130 T Curved 6.0

New ! Fall 2024

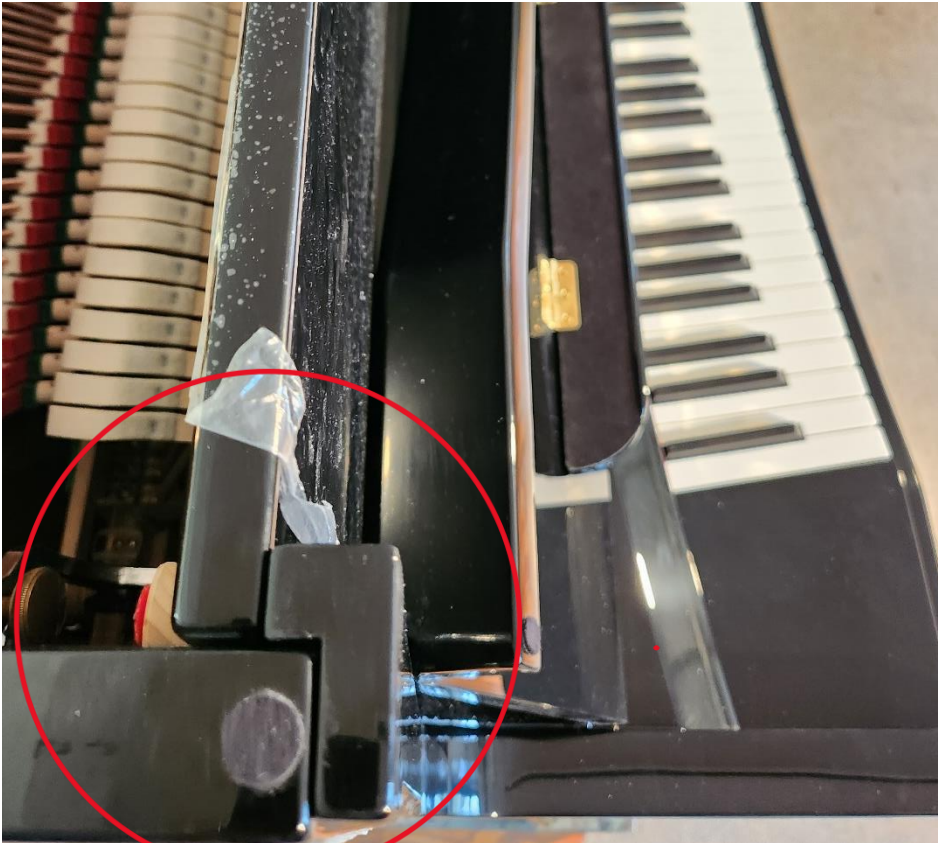
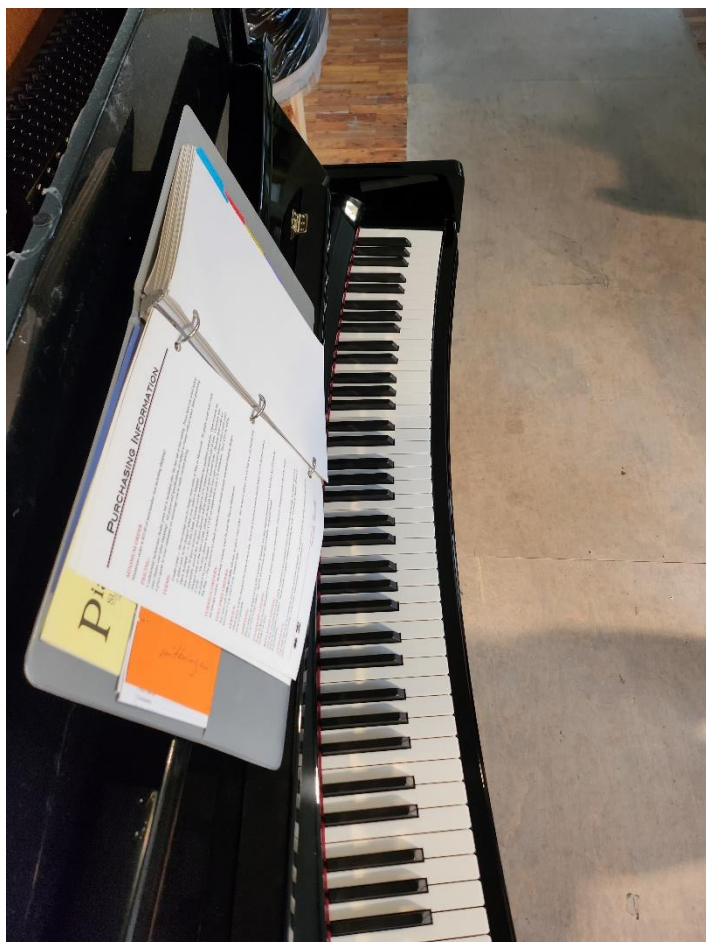
fig. on top new position of the front panel = wide angle in between fallboard and front panel created by an angled pilastre strip; it creates 10mm mor fallback of the music desk as well

fig. below: traditional position of the front panel = sharp angle in between fallboard and front panel because of the straight pilastre strip
